**BELL BEND NUCLEAR POWER PLANT
RESPONSE TO ACOE COMMENTS ON BBNPP
CWA SECTION 404 APPLICATION
BNP-2012-145 Docket No. 52-039**

Reference: 1) Letter, ACOE-2012-294, A. Elliott (ACOE) to M.J. Caverly (PPL)
"Comments on BBNPP CWA Section 404 Application", dated December 10, 2012.

SHEET TITLE:
 ENCLOSURE D1 - BBNPP WETLAND &
 WATERCOURSE IMPACT LOCATION MAP - US ACOE
 Bell Bend Nuclear Power Plant
 Luzerne County, PA

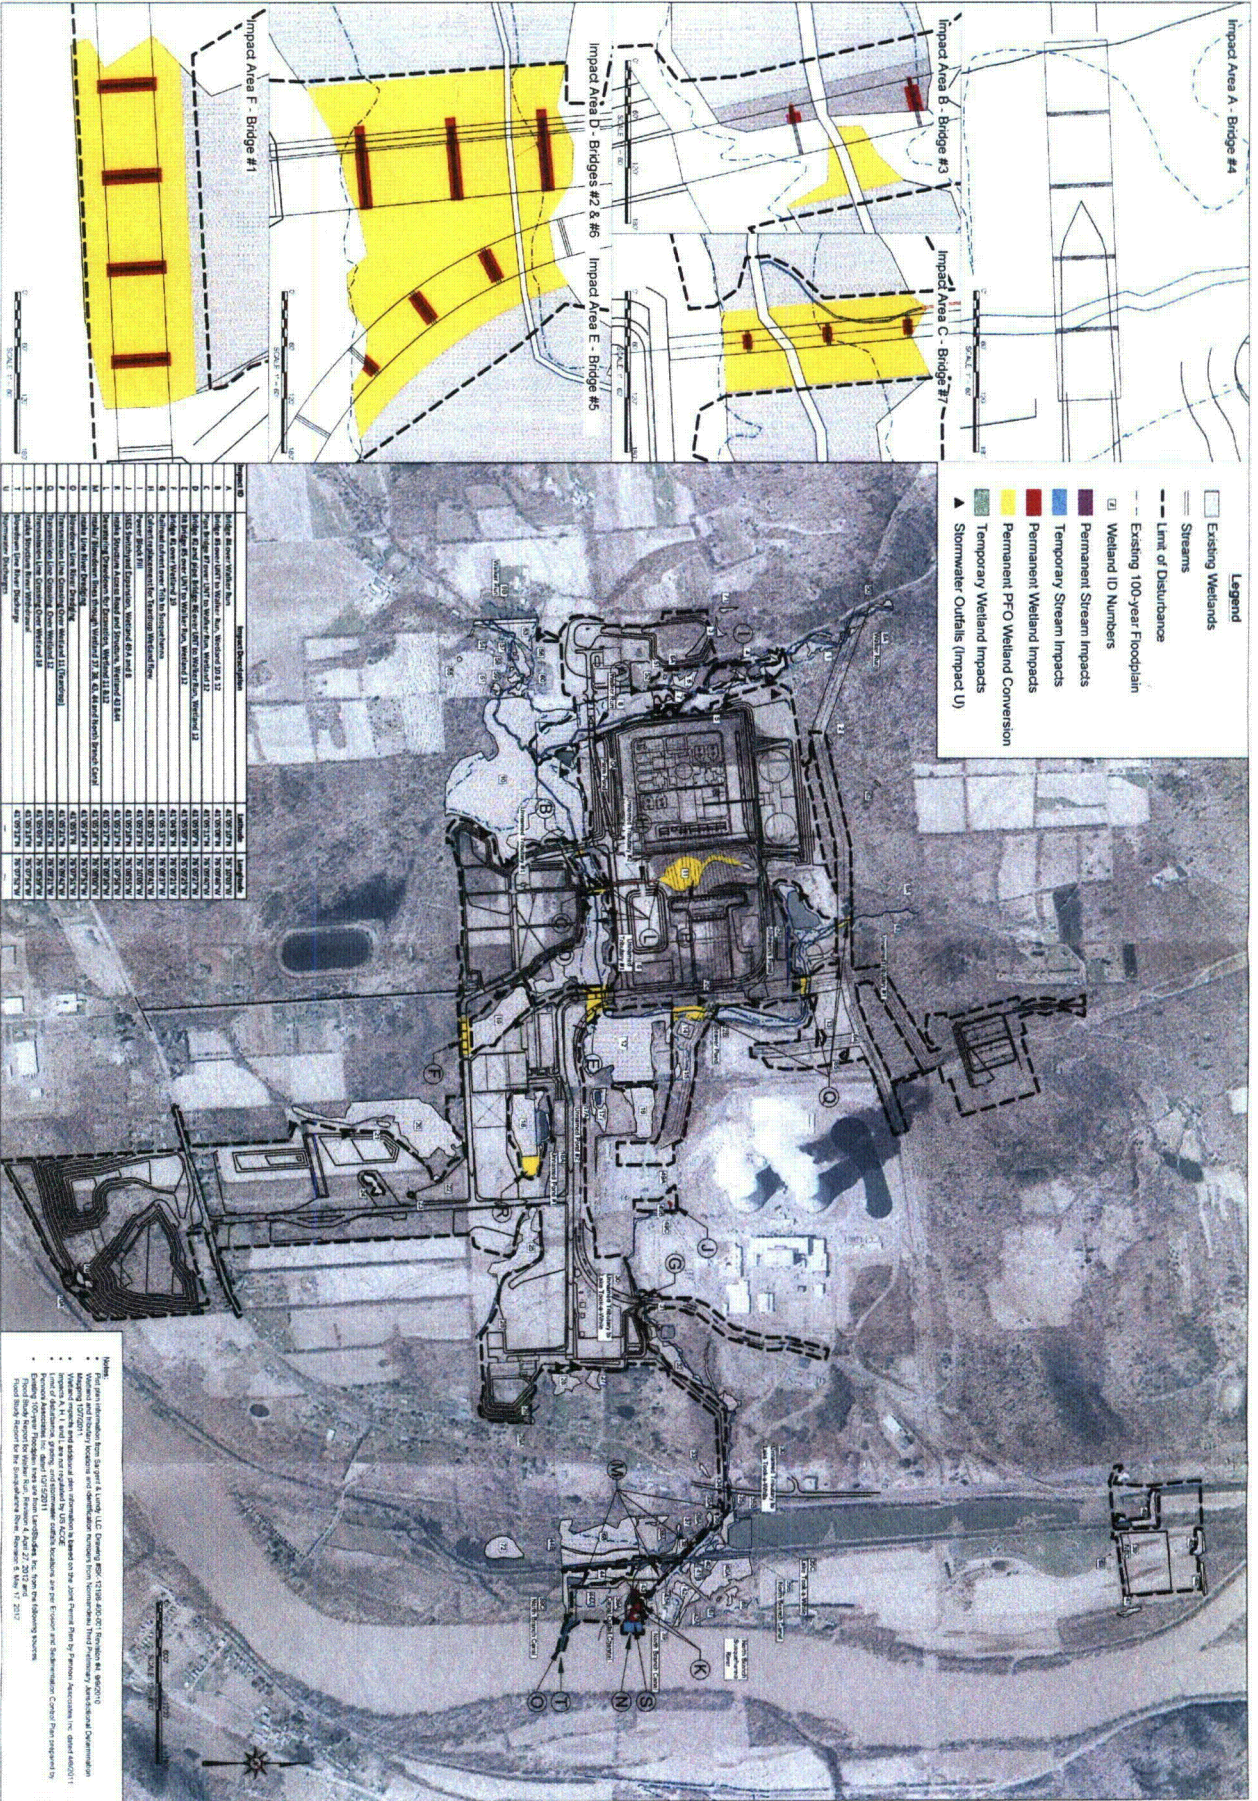
Comment 1. Please update Enclosures D1 (BBNPP Wetland & Watercourse Impact Location Map) and D3 (Table D3 – BBNPP Wetland and Watercourse Impacts and Mitigation) located in Binder 1B. As previously discussed in email correspondence from June 2012, clarification is needed on the classification of temporary impacts vs. permanent impacts vs. indirect impacts. Because not all impacts associated with this project are regulated by the Corps, the column labeled 'ACOE – indirect impacts' should be updated and better referenced as 'permanent PFO wetland conversion'. This should not change your previously submitted mitigation plan.

Response: Attached are the revised ACOE wetlands and watercourse impact location map, D1, and ACOE wetlands and watercourse impact table, D3. Per your request, we have clarified the temporary and permanent forested wetland conversion impacts on both D1 and D3. We have also characterized Impact L from the construction dewatering for the ESWEMS pond as a temporary impact resulting from the temporary reduction in groundwater elevation in the adjacent PFO wetlands. It was clarified during the June 2012 discussions that the construction dewatering associated with Impact L is a temporary PFO impact as there is no tree clearing and as such is not a Corps-regulated impact. This impact has been removed from D1 and D3 but has been retained on the PADEP documents as described in the JPA submission.
